DEP FILE E63-710
Falcon Ethane Pipeline System
Response to Technical Deficiency Letter —Washington County

On behalf of Shell Pipeline Company LP (SPLC), AECOM Technical Services, Inc. (AECOM) has prepared the following responses to the PADEP comments dated June 1, 2018. AECOM is submitting two hard copies and two electronic copies of this comment/response letter and revised documents for the Falcon Ethane Pipeline System (Project) per the discussion held with PADEP, SPLC, and AECOM on June 1, 2018. Please add/replace these documents in your existing hard copies. Per previous discussion with Josh Shaffer at the Army Corps of Engineers (Corps) and with respect to the Corps' effort to reduce paper, the Corps' copy of this comment/response letter will be uploaded to the Corps' SAFE file upload site. The technical deficiency letter, as requested, is included with this submission as Attachment A.

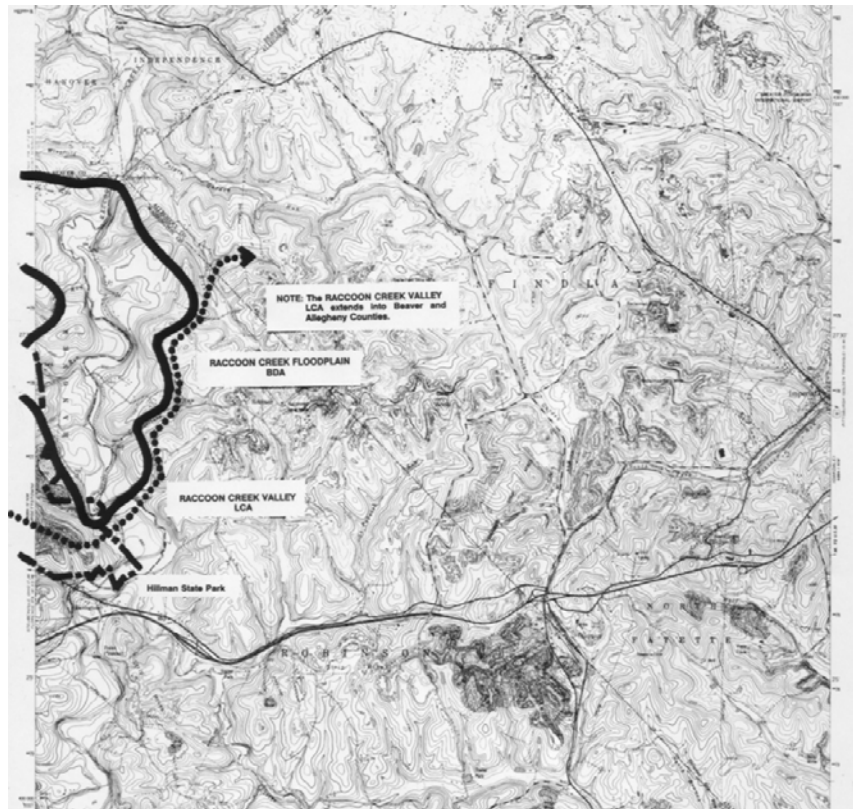
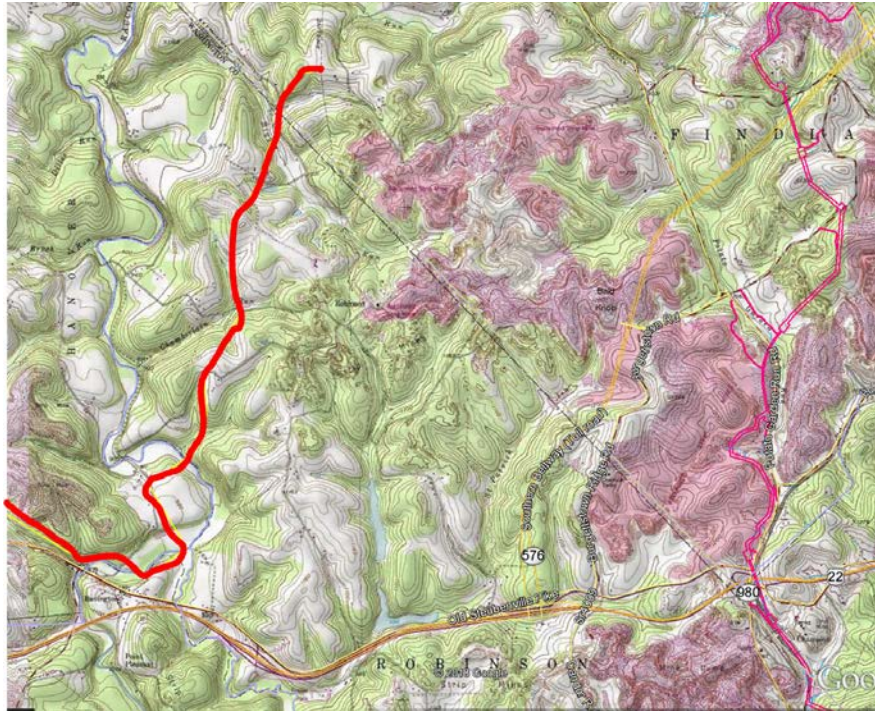
18. *The Washington County Natural Heritage Inventory, available from the PA Natural Heritage Program website, identifies the Raccoon Creek Floodplain Biologically Diverse Area and Raccoon Creek Landscape Conservation Area in or near your project area. Evaluate and discuss the potential for your project to affect these areas, pursuant to Sections 105.14(b)(4 and 12), of the Department's Chapter 105 rules and regulations.*

There will be no dams associated with this Project. All of the water obstructions/encroachments will be temporary in nature as each resource will be restored to original contours following construction. No above-ground permanent watercourse or wetland fills are proposed for this Project.

The Washington County Natural Heritage Inventory (January 1994) describes Raccoon Creek Valley Landscape Conservation Area (LCA) as a very large tri-county LCA that links a minimally developed, largely forested landscape at the juncture of Allegheny, Washington and Beaver Counties. Included in Washington are several significant natural communities containing unique plant and animal species. It is listed as an area of Exceptional Significance. The Raccoon Creek Floodplain BDA is located within this area, as seen on the below screenshot taken from the County Inventory. The Washington County Natural Heritage Inventory identifies the Raccoon Creek Floodplain Biologically Diverse Area (BDA) as a large, diverse floodplain area containing floodplain forest and floodplain swamp communities as well as two plants and one animal of special concern in Pennsylvania. It is considered a site of Exceptional Significance.

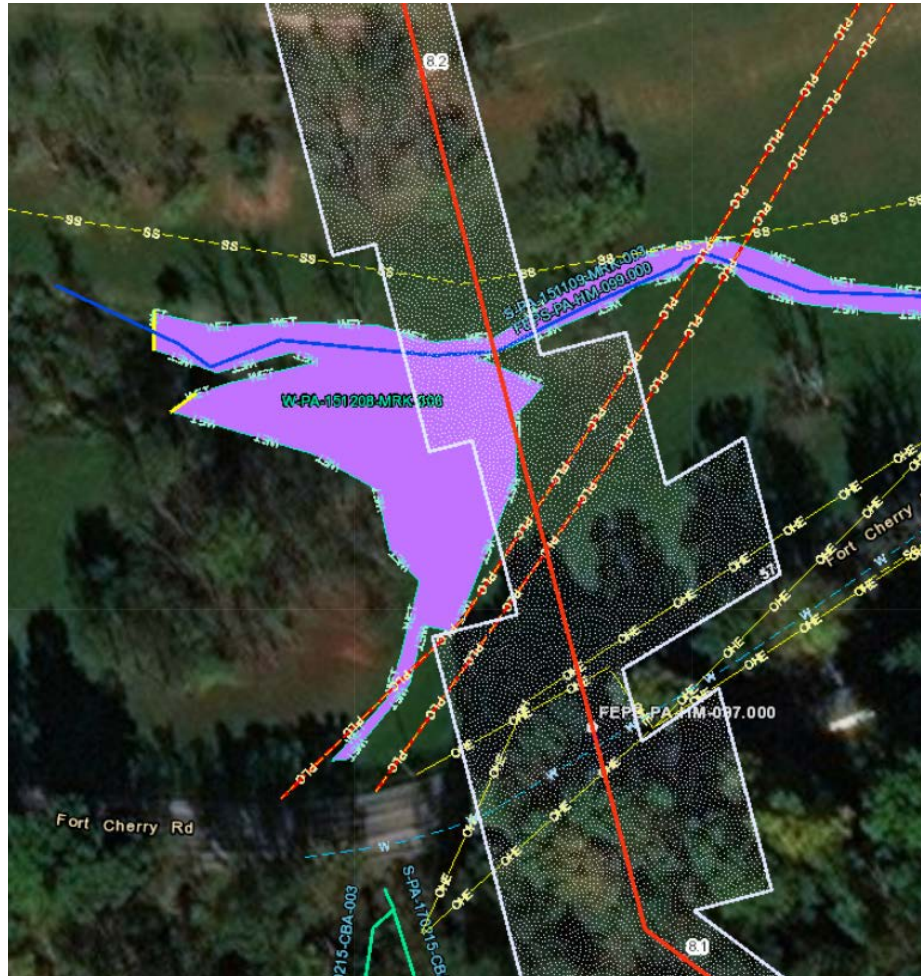
- c. *Adjusting route between MP 6.0 to 7.5 to avoid or minimize associated impacts.*

The route between MP6.0 and 7.5 was re-analyzed to determine where changes could safely be made to reduce impacts. As in the area between MP0 and 1.5, joint-drag sections were utilized when it was safe to do so. The following impact minimizations occurred:

- S-PA-151215-MRK-004 (RC-24)
- W-PA-151215-MRK-003 (RC-25)
- W-PA-170214-CBA-003 (RC-27)
- S-PA-151208-MRK-003 and W-PA-170413-RCL-005 (RC-30)
- W-PA-170215-CBA-002 (RC-31)

The LOD reduction at RC-30 eliminated any impact to W-PA-170413-RCL-005, which is a PSS wetland. Revised plan view mapping is provided in Attachment I, the revised impact table is included as Attachment J, and revised site-specific drawings are included as Attachment K. Revised E&S drawings are provided in the updated E&SCP included with this response to comments package.

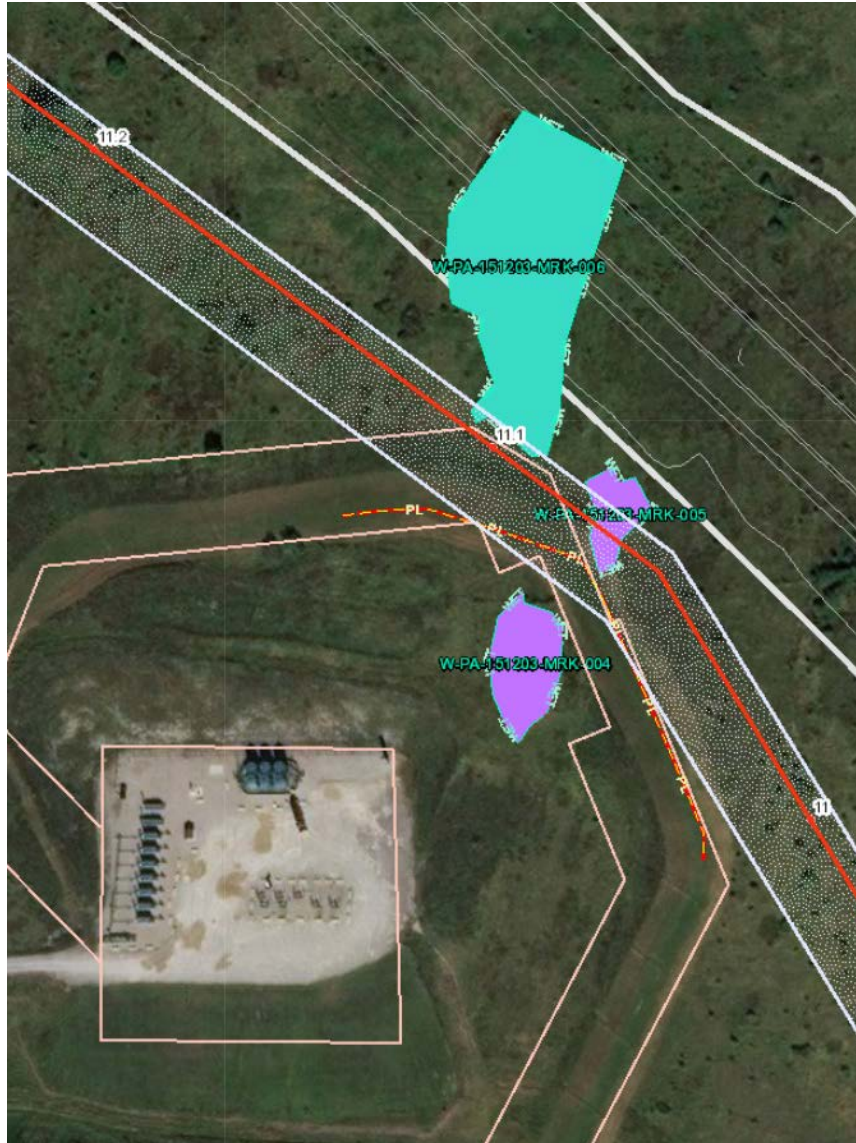
- f. *Adjusting route to avoid or minimize impacts at RC-40 and RC-41.*
 This was the only location that the pipeline could be routed through this area. This is due to the existing MarkWest pipeline (red and yellow dashed line in the screenshot below) and facility in the screenshot below. The LOD for the facility is in light peach below. Due to the facility and the slope down to the facility, the Project could not shift further south. Additionally, the Southern Beltway Project will be constructed through this area. The thick white lines in the screenshot below represent the outer LOD for that project. As a result, the Project could not be shifted north. Given that the wetland is located on the pipe side of

the LOD, the LOD cannot be necked down here. However, the permanent easement was reduced, which minimized impact in the permanent ROW and increased impact in the temporary ROW. The impact table in Attachment J has been revised to show the new impact numbers.
